This submission sets out **material** concerns with DA2025/0272, specifically the slope exacerbated privacy loss, excessive bulk and scale, and misrepresentation of overshadowing impacts. Council's own assessment unequivocally acknowledges non-compliance with B3 and B9 controls, yet seeks to invoke flexibility provisions without demonstrating that the mandatory objectives of those controls are achieved. Such an approach is procedurally unsound and contrary to the intent of the DCP.

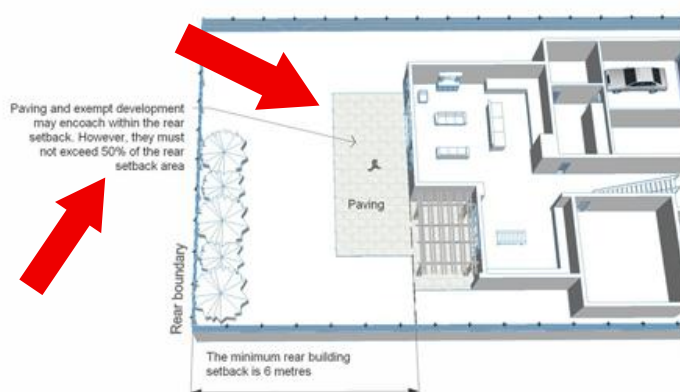
- The ground-floor rear deck is elevated relative to our lot, functioning as a raised viewing platform into principal private open space (PPOS) and habitable rooms.

- First floor rear and side windows provide **unimpeded sightlines into neighbouring PPOS**. Only W-08 is conditioned for treatment, leaving other openings untreated.

- Four south-facing windows **directly** face our lot. The slope enables **direct downward views** into PPOS and habitable rooms. Without privacy glazing, these openings breach the objectives of privacy protection.

- The west-facing window on the same elevation as W-08 also has direct sightlines into adjoining PPOS and directly into our ground floor bedrooms. If W-08 warrants privacy screening, then the west-facing window must be treated to the same standard to ensure **consistent** and effective privacy protection.

- **No section drawings or sightline** analysis verify the claim that separation distances prevent overlooking.

- Apply privacy treatment (translucent glazing, high sill heights, fixed screening) to **all rear, side, and west-facing windows overlooking adjoining PPOS**, including all four south-facing windows and the west-facing window adjacent to W-08.
- Install permanent, non-permeable screening to a minimum height of 1.8 m above finished deck level on southern and rear edges.

(Figure 2) - Amended Plan – Non-Ground Level Deck on Sloped Topography

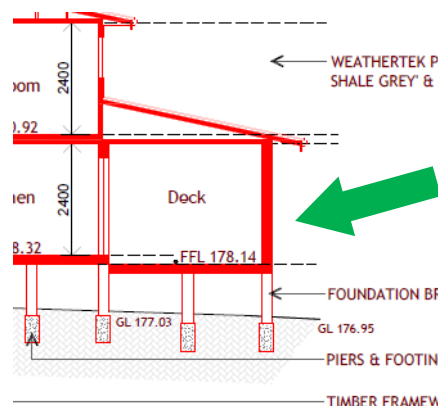
Council's report states that the amended plans achieve compliance for the ground-floor deck, which in fact encroaches into the rear setback. Part B9 permits encroachments **only for paving and exempt development at ground level (Figure 1)** covering no more than 50% of the setback area.

- The **proposed structure is an elevated open deck (Figure 2)**, not ground-level paving, and **does not qualify for this concession** as per the WDCP B9.

- On this sloping site, **the deck is significantly elevated** above adjoining natural ground, creating a raised platform that increases visual bulk and direct overlooking into lower neighbouring properties.
- The WDCP control is prescriptive and applies regardless of neighbouring breaches, referencing other approvals does not negate site specific amenity impacts.
- The allowance in B9 for paving does not extend to elevated structures that function as building elements.

- Remove the elevated deck from the setback area and replace it only with compliant ground level paving or exempt development covering no more than 50% of the setback;
- If retention is sought, incorporate permanent non-permeable screening, measured from the finished floor level of the deck to the adjoining natural ground level, to eliminate overlooking impacts.
